Transportation Advisory Board

SUBJECT: JOINT REVIEW FOR THE 610 HOMESTEAD ROAD ARCHITECTURALLY INTEGRATED SUBDIVISION SPECIAL USE PERMIT.

PROJECT: 610 Homestead Rd Architecturally Integrated Subdivision
Special Use Permit

SUP - SITE PLAN

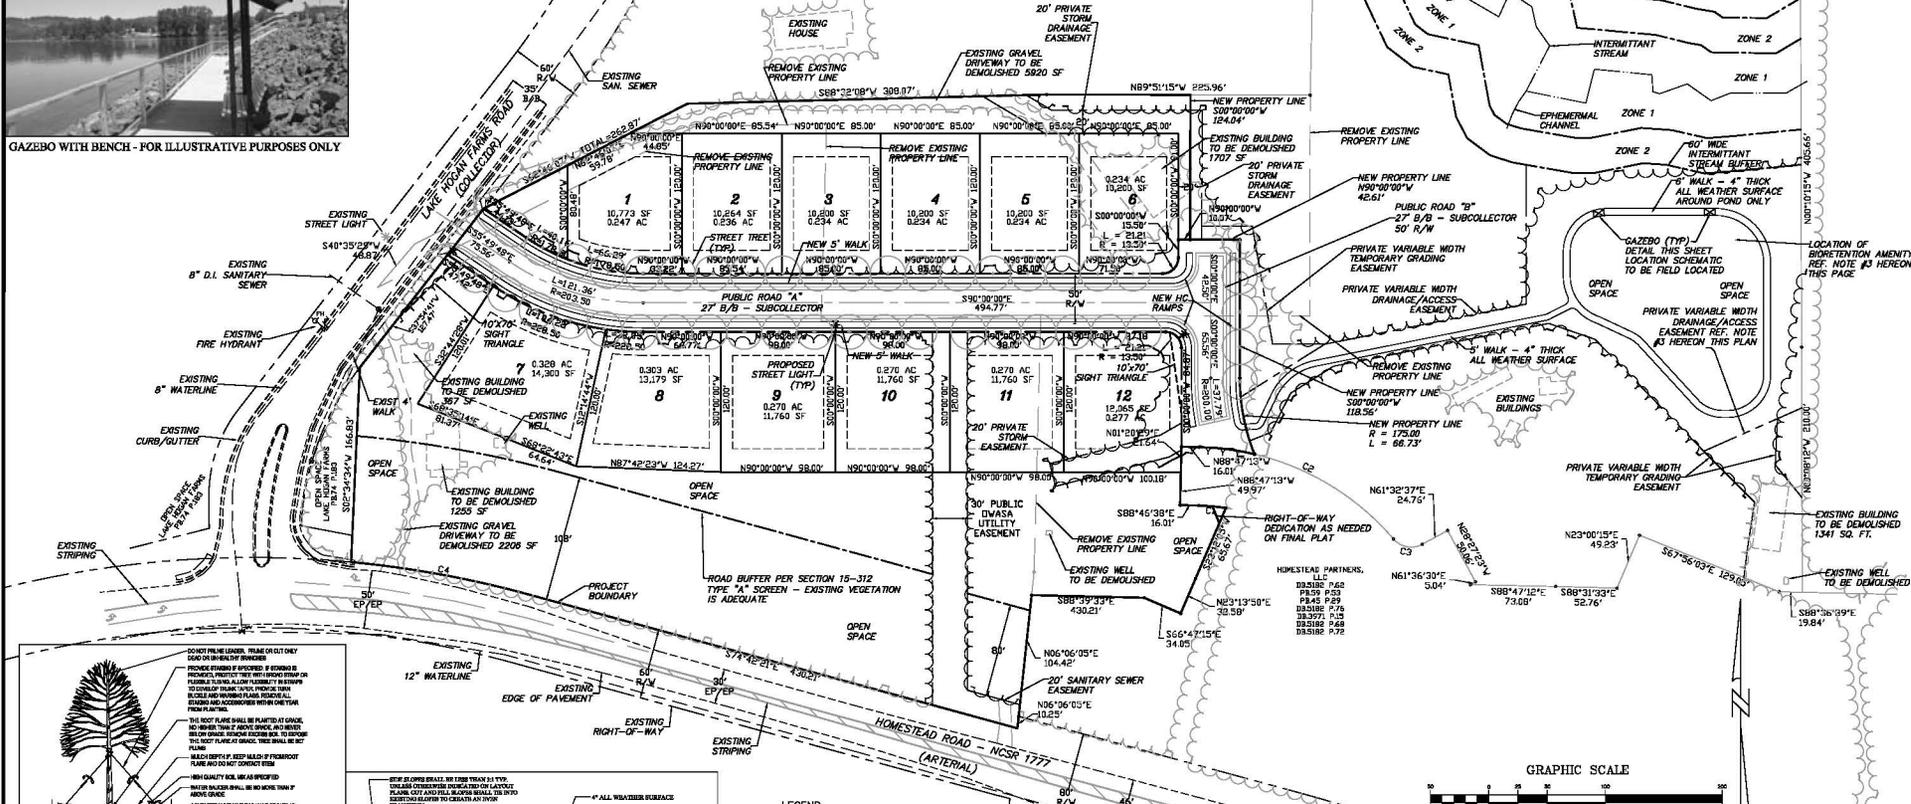
The landscape plan proposes 43 large street trees, 21 of which are Red Maples and the remainder, Willow Oak. These are shown to demonstrate compliance with the street screening requirements of section 15-308. None of the proposed plantings are on the Town's List of Invasive Plant Species on Appendix E-17 of the LUO. These plans will be reviewed further during construction plan review.

Section 15-315 of the LUO provides guidelines for the planting and retention of trees adjacent-to and within street R/W's where an offer of dedication has been made to the Town. The landscape plan proposes a street tree layout primarily within the R/W with a fairly uniform pattern. However, because existing trees may be preserved during the construction process staff recommends that the proposed layout be considered only as a possible scheme and that the street tree requirement be revised as needed so that it may be field adjusted as conditions warrant. Additionally, the Town's policy is to require that 1/3rd of all such trees be evergreen. For these reasons, the following condition is recommended:

- That flexibility be allowed in the execution of the street tree planting plan (subject to the approval of public works and the planning department), such that the combination of existing and proposed trees along all publicly dedicated streets in the subdivision meet the street tree requirements of Section 15-315 of the Land

GRAVING / EROSION CONTROL PLAN

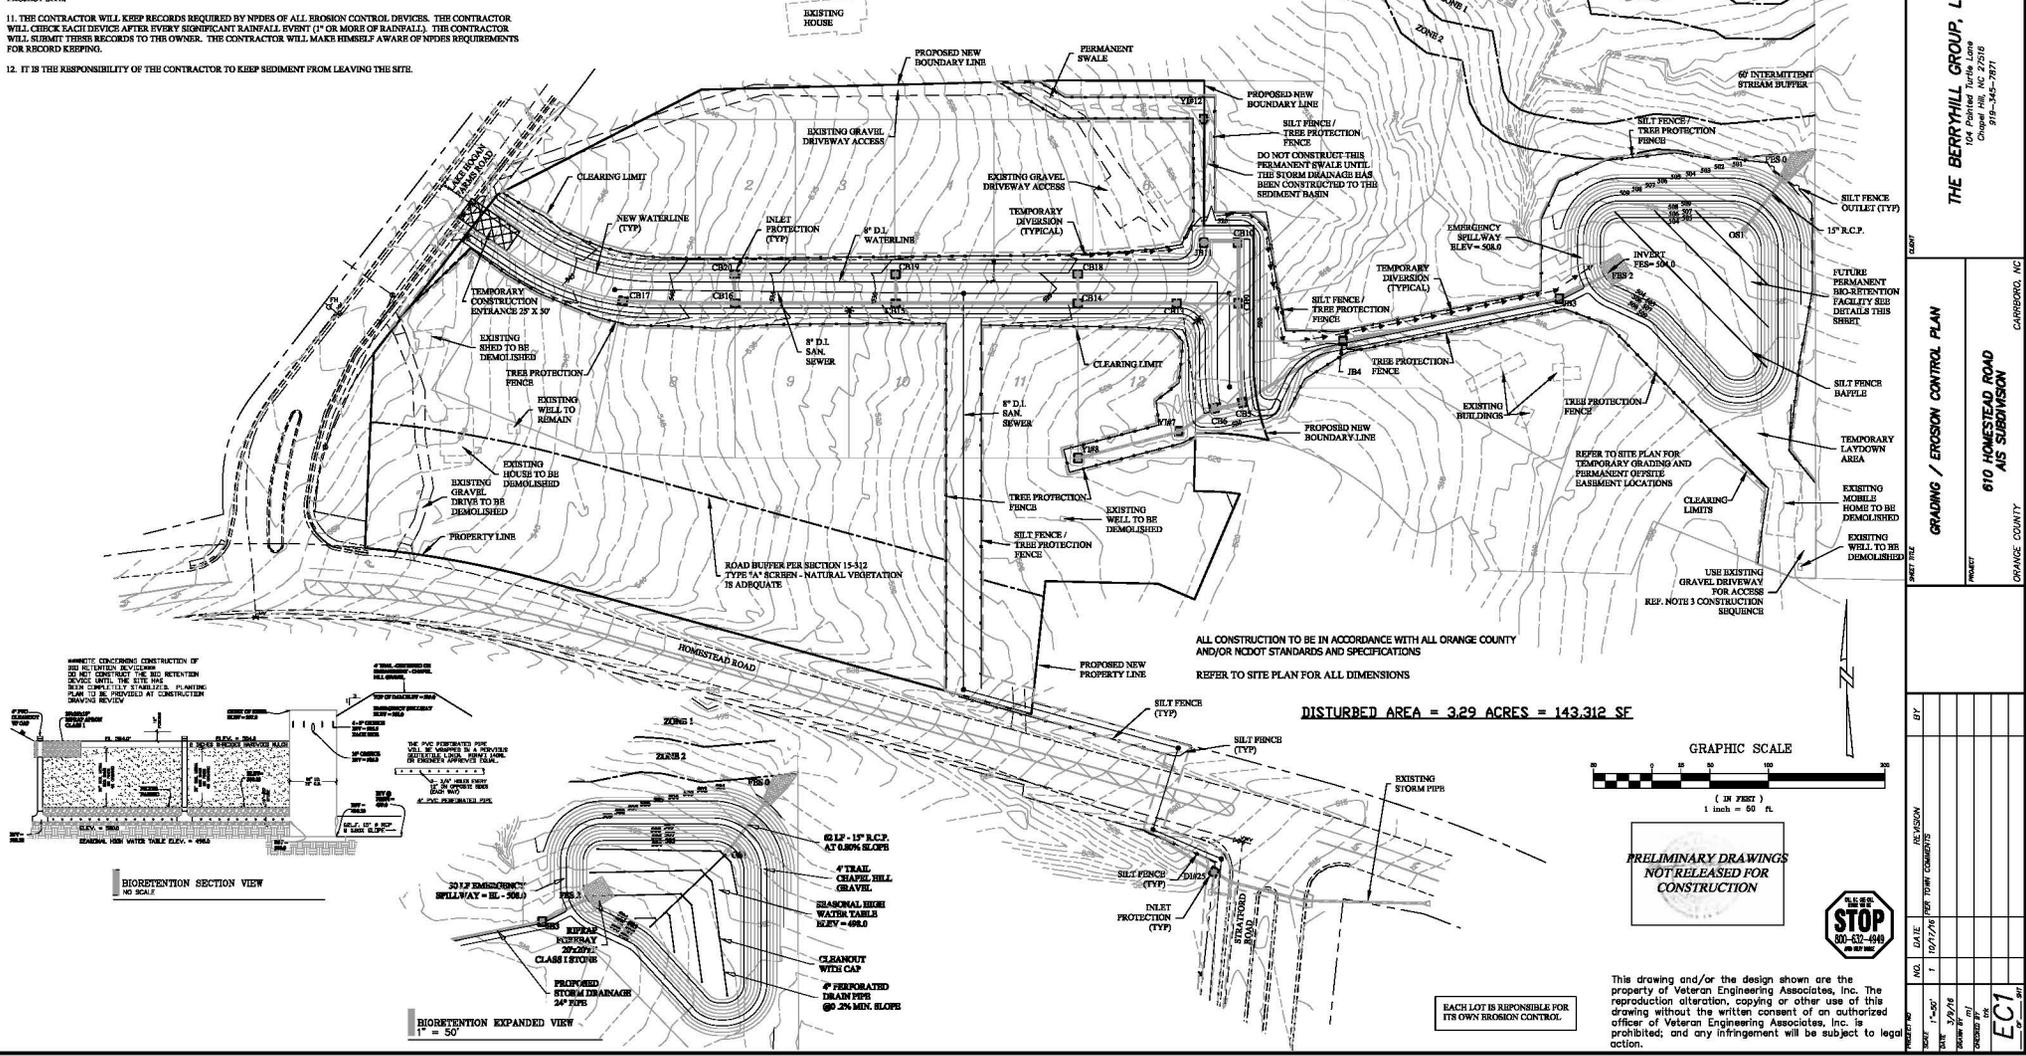
To this end, the grading and drainage plan show a system of curb and gutter, catch basins and pipes that collect and direct water to a large bioretention basin east of the lots. This basin and its associated appurtenance will be located off-site within a private stormwater easement on the adjacent lot.

The grading plan limits the grading disturbance to the installation of the street, stormwater devices and the walking path. Additional minor grading would be expected on the individual lots during home construction.

A simple erosion control plan has been provided which is provisionally satisfactory to Orange County Erosion Control. Additional details will be provided as part of the Construction Plan review process.

- Per Section 15-263.1, that the developer shall include a detailed stormwater system maintenance plan, specifying responsible entity and schedule. The plan shall include scheduled maintenance activities for each stormwater BMP in the development, performance evaluation protocol, and frequency of self-reporting requirements (including a proposed self-reporting form) on maintenance and performance. The plan and supporting documentation shall be submitted to Town engineer and Environmental Planner for approval prior to construction plan approval.
